EXHIBIT: PacifiCorp PAC_400
CPUC PROCEEDING: H.25-07-005
SPONSOR/WITNESS: PacifiCorp/Brian King
DESCRIPTION: Public - PAC0008350 – LRA Verification NV5 Vegetation Management Inspection Reports
DATE IDENT. _____ RECD. _____
ALJ: GERALD F. KELLY

Tier 2 and WUI - Random Sample

VEGETATION MANAGEMENT INSPECTION REPORT

ID1314

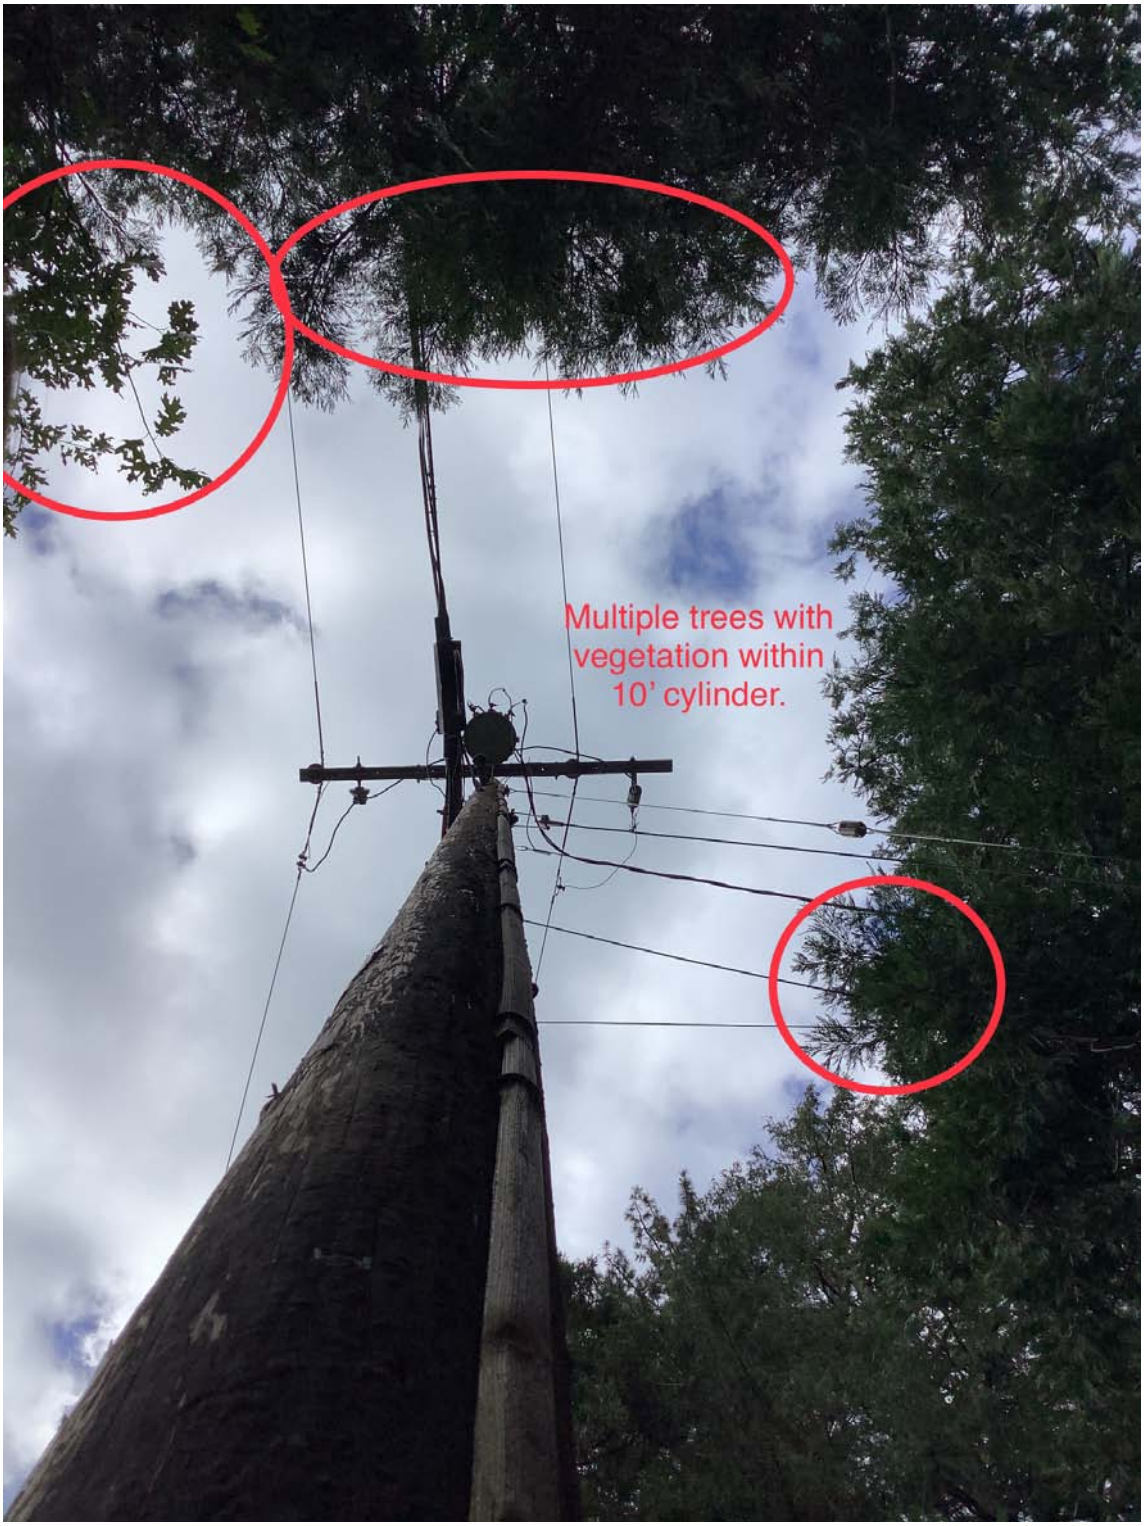
Multiple trees with vegetation within the ground to horizontal line height compliance cylinder.

Multiple trees with
vegetation within
10' cylinder.

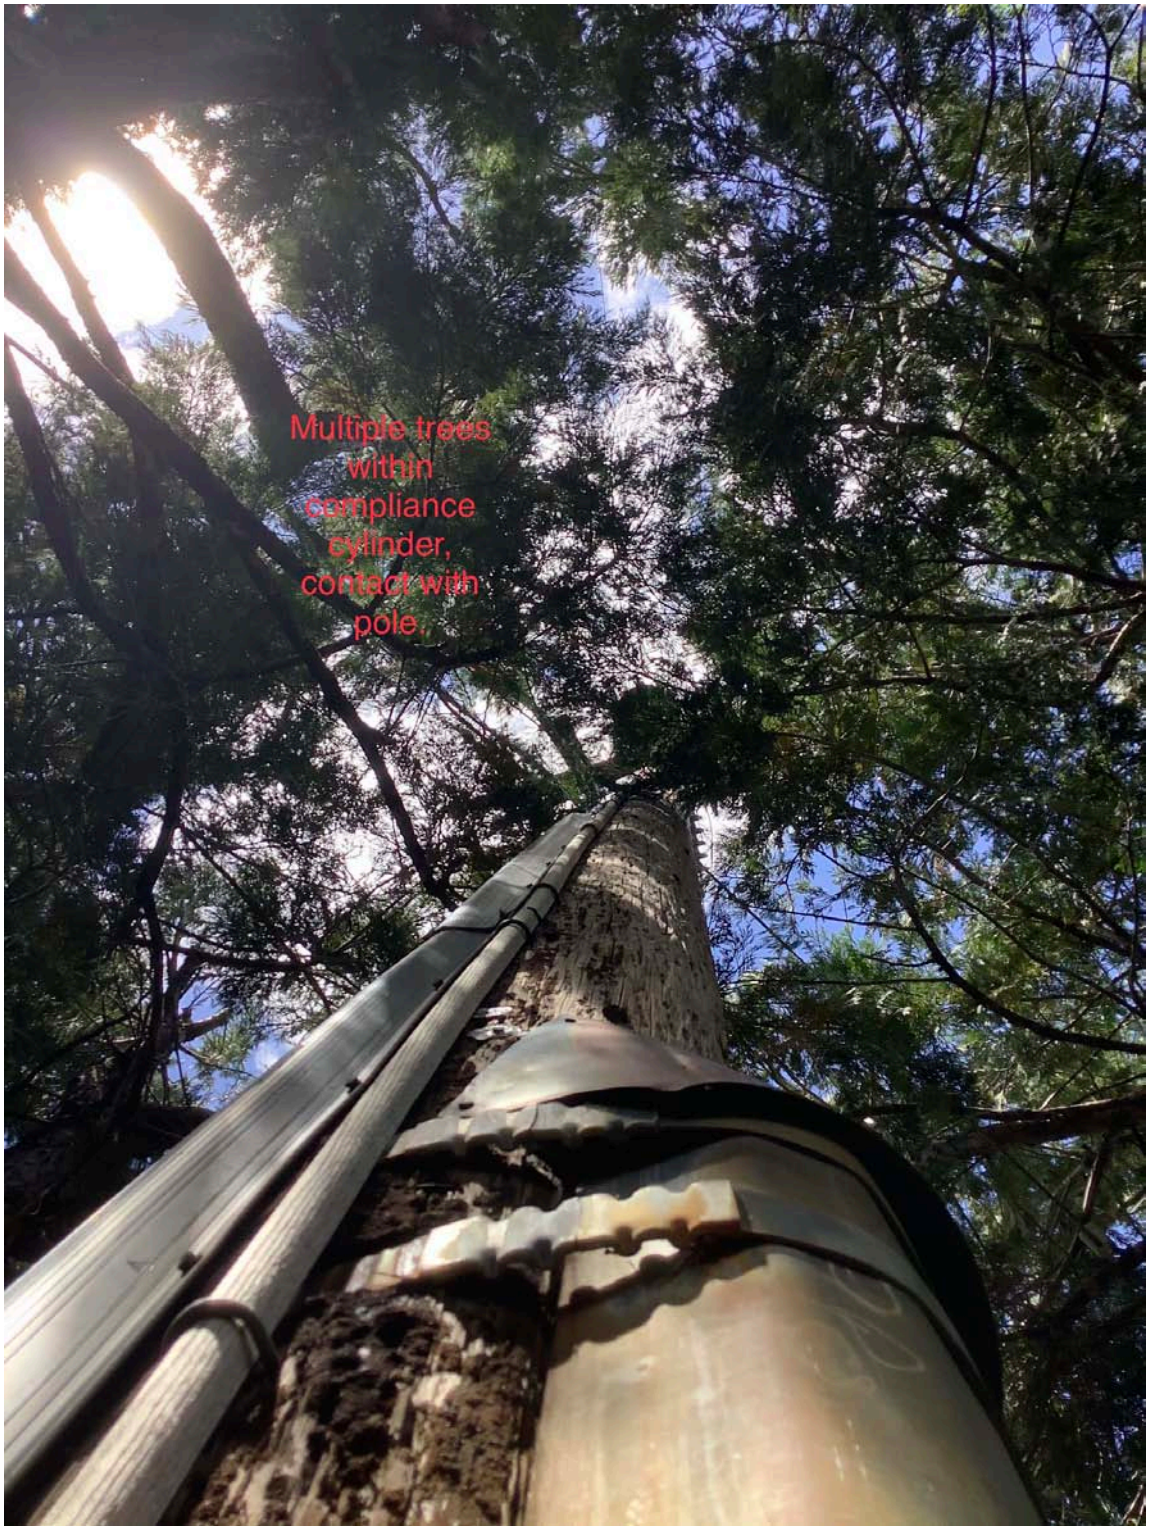
Multiple trees with vegetation within the ground to horizontal line height compliance cylinder, no clear path from hardware to ground.

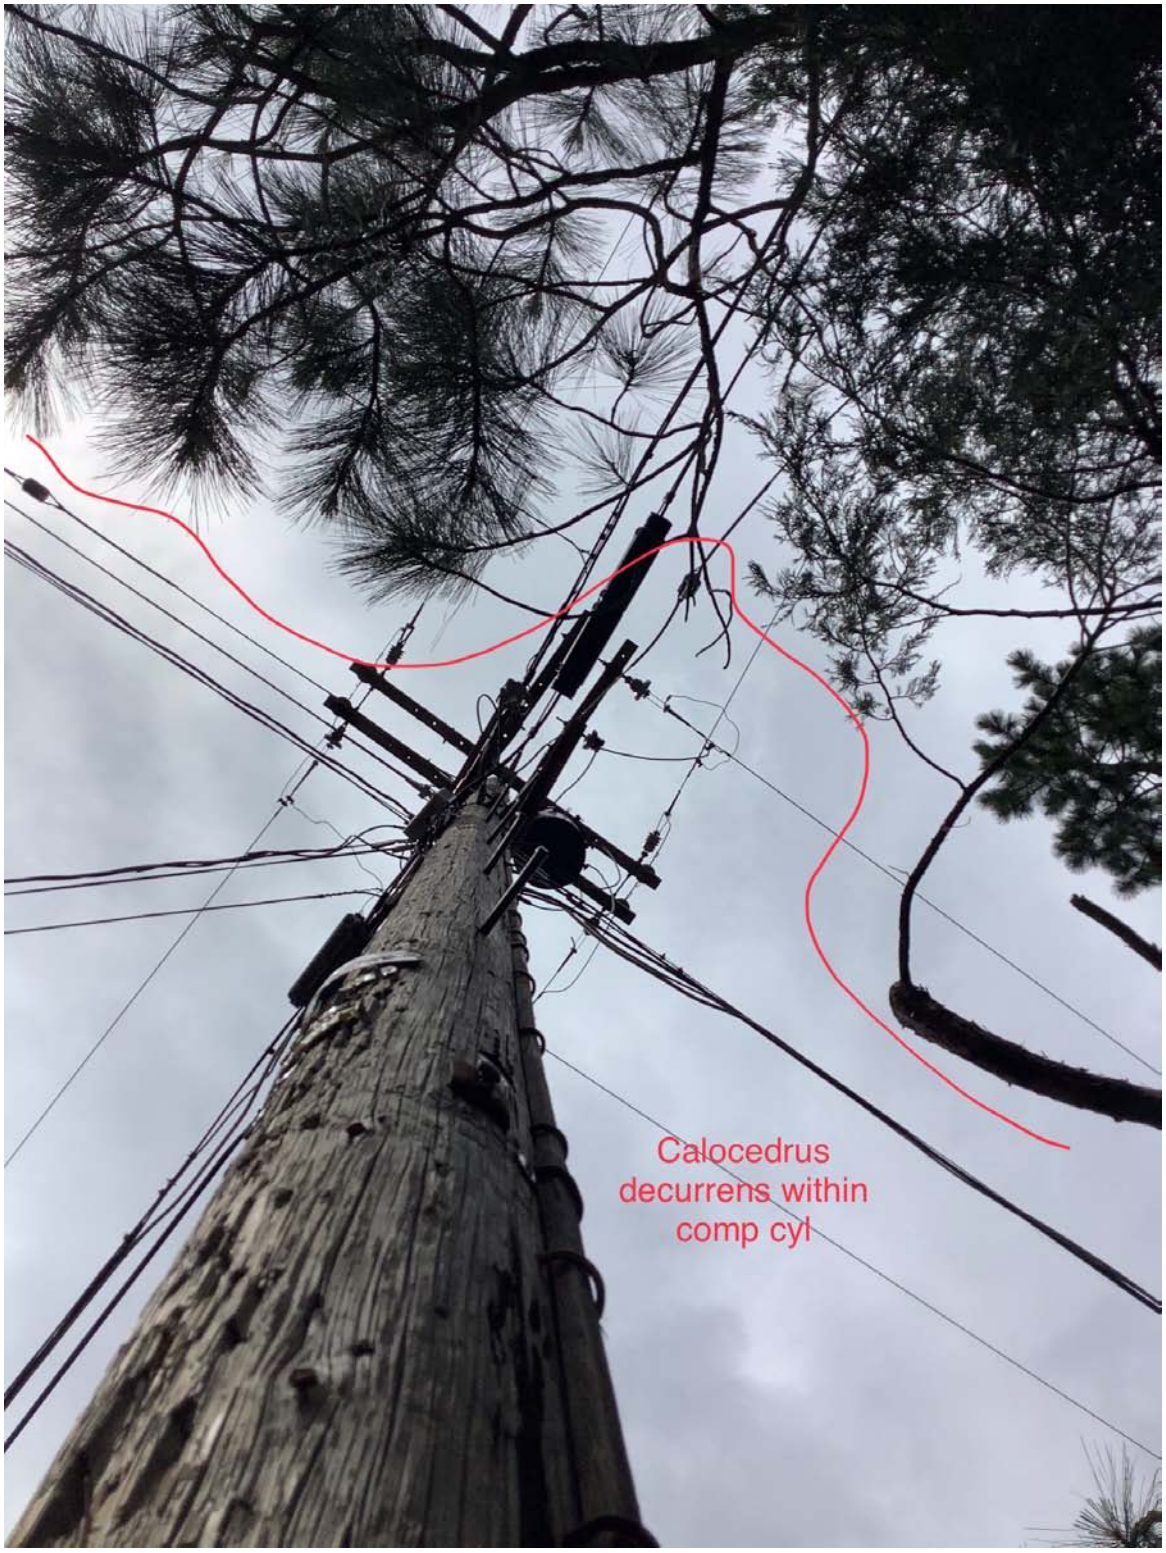
Calocedrus decurrens vegetation within the ground to horizontal line height compliance cylinder
